State of New Mexico
 Energy, Minerals and Natural Resources

WELL API NO. 30-015-35337
5. Indicate Type of Lease STATE ☐ FEE ☒ FEDERAL ☐
6. State Oil & Gas Lease No.
7. Lease Name or Unit Agreement Name BIG CHIEF FEE
8. Well Number 010
9. OGRID Number 228937
10. Pool name or Wildcat DUBLIN RANCH; ATOKA (GAS)

SUNDRY NOTICES AND REPORTS ON WELLS
 (DO NOT USE THIS FORM FOR PROPOSALS TO DRILL OR TO DEEPEN OR PLUG BACK TO A DIFFERENT RESERVOIR. USE "APPLICATION FOR PERMIT" (FORM C-101) FOR SUCH PROPOSALS.)

Action 397942

Big Chief Fee #010
990' FNL & 990' FWL Sec. 22-22S-28E
Eddy County, NM
API: 30-015-35337
CURRENT WELLBORE SCHEMATIC
Spud: 02/08/2007

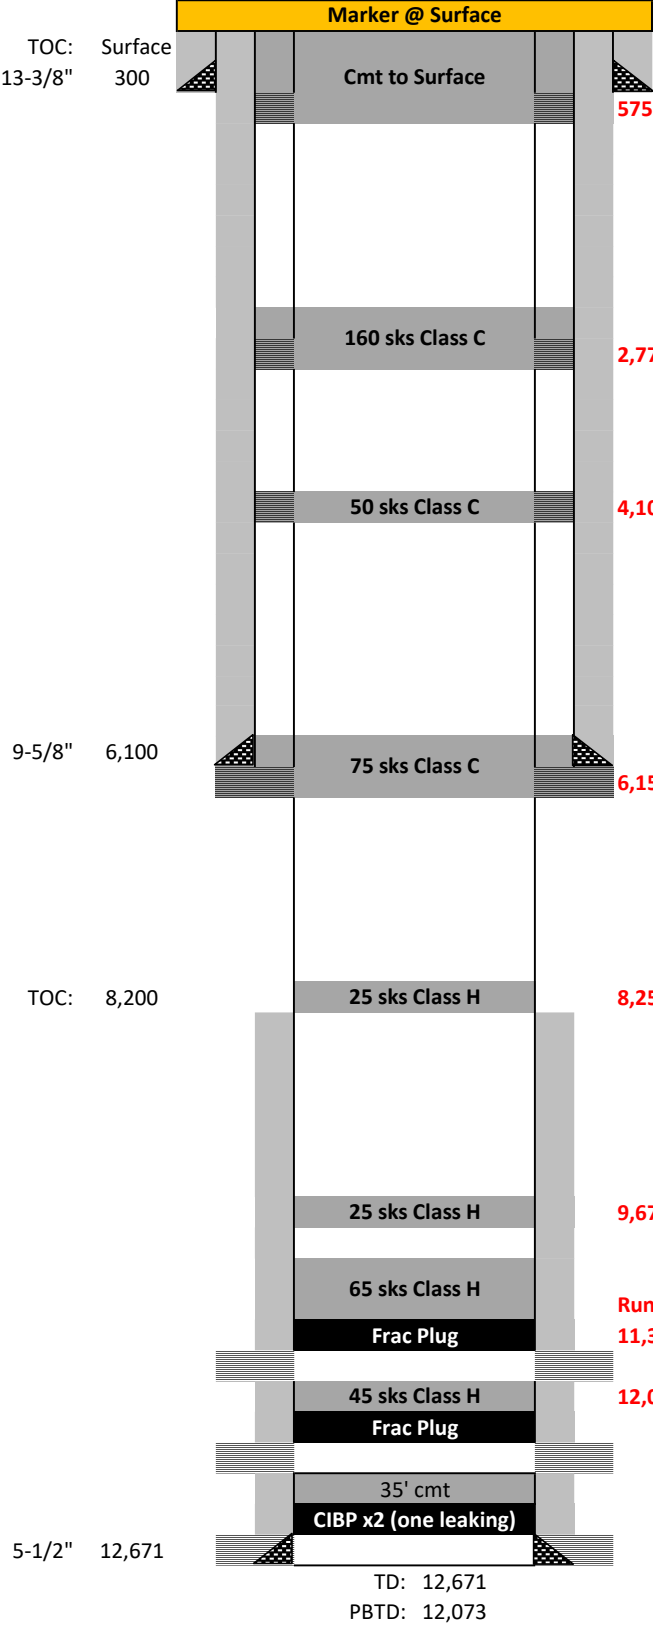
575': Perf & Squeeze Class C cmt to surface on all strings (Est. ~185 sks) (Surface Shoe)

2,770': Perf & Squeeze 160 sks Class C cmt (Est. 2,274' / Req. 2,317') (Bell Canyon, Delaware, & Base of Salt); WOC & Tag

4,100': Perf & Squeeze 50 sks Class C cmt (Est. 3,945' / Req. 3,986') (Brushy Canyon); WOC & Tag

6,150': Perf & Squeeze 75 sks Class C cmt (Est. 5,917' / Req. 6,000') (Intermediate Shoe & Bone Spring); WOC & Tag

8,250': Spot a 25 sk Class H cmt balanced plug (Production Casing TOC)

9,670': Spot a 25 sk Class H cmt balanced plug (Wolfcamp)

Run CBL to Surface

11,300': RIH & Set CIBP; TIH & Circulate wellbore full of MLF; Pressure Test casing to 500 psi for 30 minutes & Bubble test; Spot 65 sks Class H cmt on CIBP (Est. 10,771' / Req. 10,823') (Open Perforations, Atoka, & Strawn); WOC & Tag.

12,073': TIH & spot 45 sks Class H cmt on plug (Morrow).
